Work Order ID **94342**

Item Name: Crosstube Assembly, Mid Aft

DART AEROSPACE LTD HAWKESBURY, ONTARIO, CANADA	
DRAWING NO. D206-667-247	REV. A SHEET 1 OF 4
TITLE CROSSTUBE ASSY (206L MID AFT)	SCALE NTS
COPYRIGHT © 2010 BY DART AEROSPACE LTD THIS DOCUMENT IS PRIVATE AND CONFIDENTIAL AND IS SUPPLIED ON THE EXPRESS CONDITION THAT IT IS NOT TO BE USED FOR ANY PURPOSES OR COPIED OR COMMUNICATED TO ANY OTHER PERSON WITHOUT WRITTEN PERMISSION FROM DART AEROSPACE LTD.

DRAWING NO. D206-667-247	TITLE CROSSTUBE ASS'Y (206L MID AFT)	REV. A	DART AEROSPACE LTD ENGINEERING ORDER		D.E.O. NO. D206-667-247-A-1	SHEET NO. SHEET 1 OF 1	SCALE NTS
DRAWN 90	CHECKED ASS	MFG. APPR. KJ	APPROVED JMP	DE APPR. H			
DATE 11.07.15	DATE 11.07.20	DATE 11.07.21	DATE 11/07/21	DATE 11.07.21

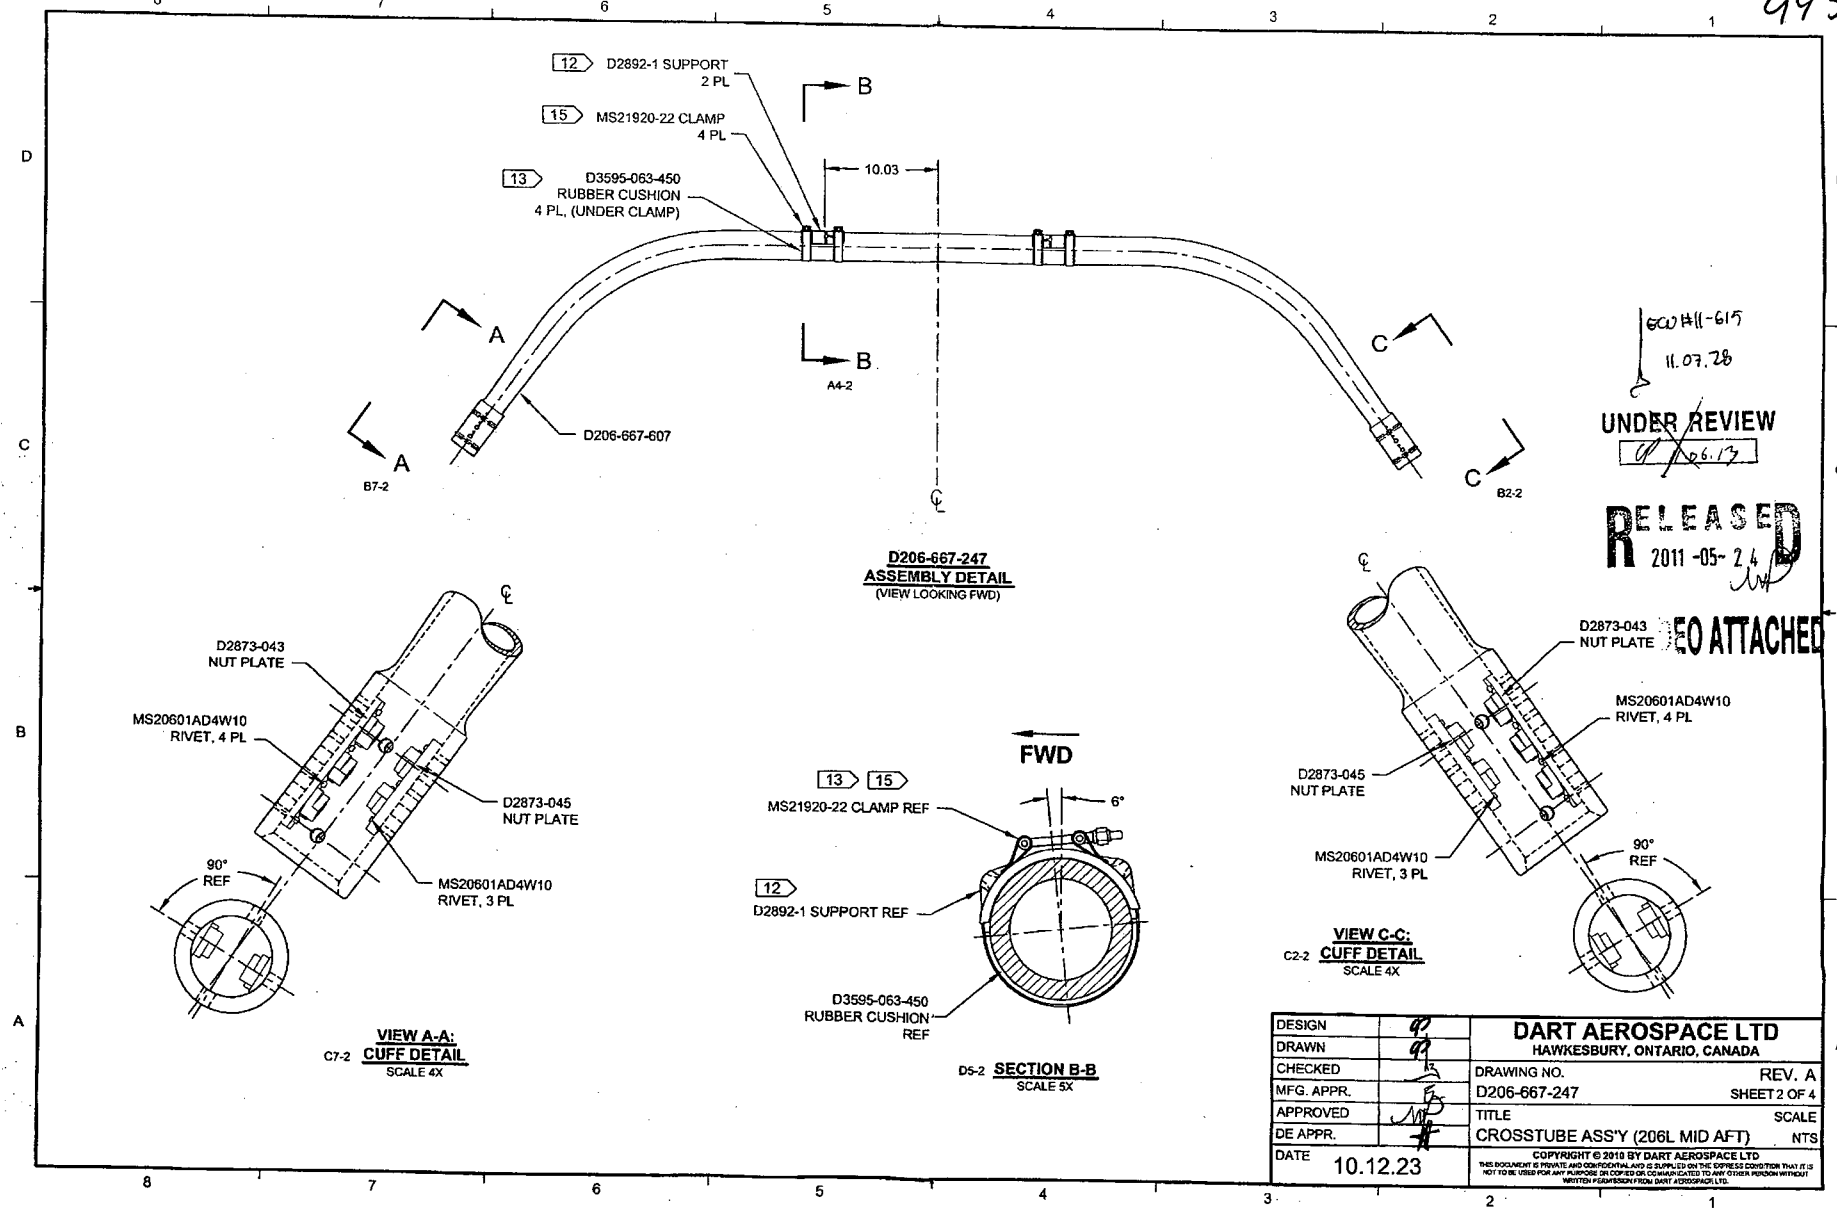
PURPOSE:

REPLACE MAGNOBOND WITH PROSEAL.

CHANGE:**IS:**

Item	Qty -247	Part Number	Description
9	A/R	PROSEAL 890 B-2	SEALANT, AMS-S-8802 CLASS B-2

WAS:

9	A/R	MAGNOBOND 6398	ROCKWELL SPECIFICATION RBO-120-023 ADHESIVE (TEXTRON/BELL SPEC. 299-947-100, TYPE II, CLASS 2 ADHESIVE)
---	-----	----------------	---

NOTE 12 & 15, SHEET 1 IS AMENDED AS FOLLOWS:

WAS:

- 12) INSTALL D2892-1 SUPPORT USING 0.03" TO 0.06" THICK LAYER OF MAGNOBOND 6398 PER QSI 015. LET CURE FOR 12 HOURS AFTER INSTALLATION AND PRIOR TO PACKAGING.
- 15) TORQUE CLAMPS 80 TO 100 IN.-LB. ENSURE AT LEAST 1.5 THREADS SHOWING IN SAFETY AND THAT NUT HAS NOT BOTTOMED-OUT AFTER TORQUING.

IS:

- 12) TO INSTALL D2892-1 SUPPORT: ABRASE MATING SURFACE OF SUPPORT AND CROSSTUBE WITH 180-GRIT SANDPAPER AND REMOVE RESIDUE WITH MEK (OR EQUIVALENT). APPLY A 0.04" TO 0.07" THICK LAYER OF PROSEAL 890 CLASS B-2 (OR AMS-S-8802 CLASS B-2) SEALANT TO MATING SURFACE OF SUPPORT.
- 15) TORQUE CLAMPS 80 TO 100 IN.-LB. ENSURE AT LEAST 1.5 THREADS SHOWING IN SAFETY AND THAT NUT HAS NOT BOTTOMED-OUT AFTER TORQUING. **PRIOR TO PACKAGING, RE-CHECK TORQUE ON CLAMPS AFTER PROSEAL 890 SEALANT HAS CURED FOR 72 HOURS.**
